PERMIT

SEWAGE DISPOSAL SYSTEM
HOWARD COUNTY HEALTH DEPARTMENT
BUREAU OF ENVIRONMENTAL HEALTH
410-313-2640

SUBDIVISION Twelve Hills ^{GOTTLIEB} LOT NUMBER .37 ADDRESS 14004 Twelve Oaks Court ^{OSHELM}

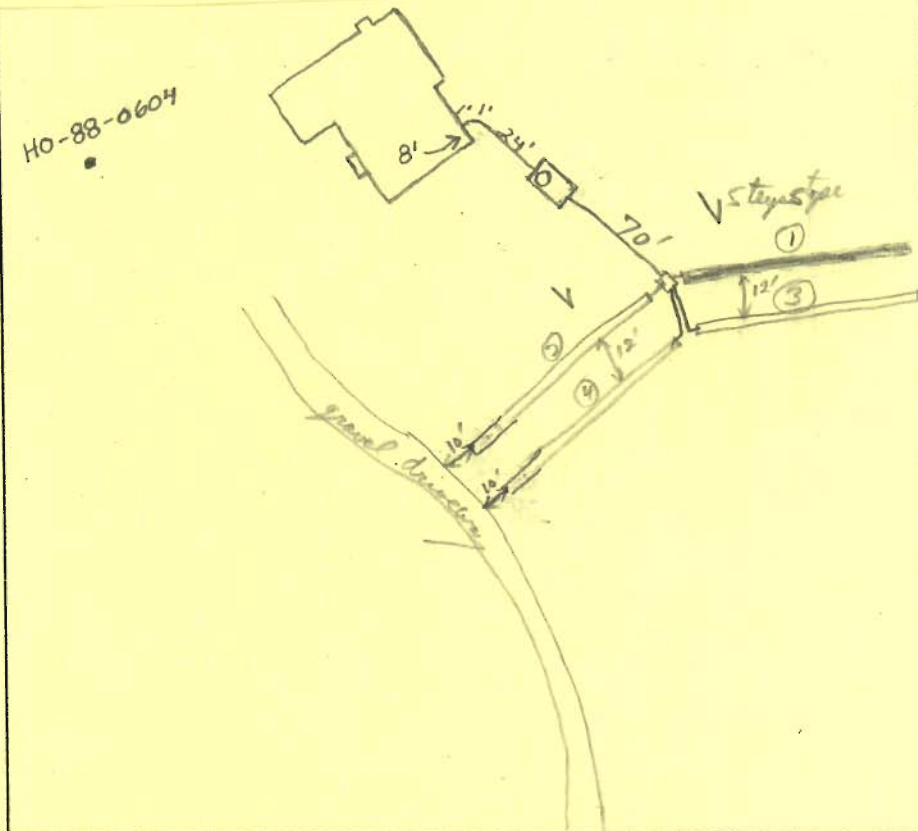
To His Honor the soil in trench #4, plus the other trench #2 & 4. Head to 1 about all good soil, Tr 2 70% good soil, Tr 3 was 50% good soil bottom but Tr 4 was 100% on clay loam soil but because of poor contour he is almost 6 1/2 - 7' deep at one end & 5' deep at other end. OK If this system doesn't last at least 10 yrs, Next Sanitarian should ensure all trench bottom penetrates into sandier soil or design system on appropriate slope per notes. RPP 2/22/01

I called & left Message with Silvia to give
to Ketterman to do No More work
out there until he called Me.
this concerns trencher dig into clayier
Soil than should have been.
(see My Material file)

First 2 trenches correct, 3rd trench gravelled but not piped, 4th trench open (bottom all way still in gravelly clay loam soil)
Steady, working (K&K planning books) From Trenching Spore these trenches are in clay loam soil. Not sandy loam soil of pure tests.
Hardest deeper Trench into sandy loam or pure this sandy loam soil and dirt through extra trench (≈ 160 LF more) to compensate
for down penetrating of clay loam soil. RPP 2/22/01 extension of 244 OK (getting into sandier soil), Soil Box OK. R/P 2/26/01
OK to Cover soil w/ R/P
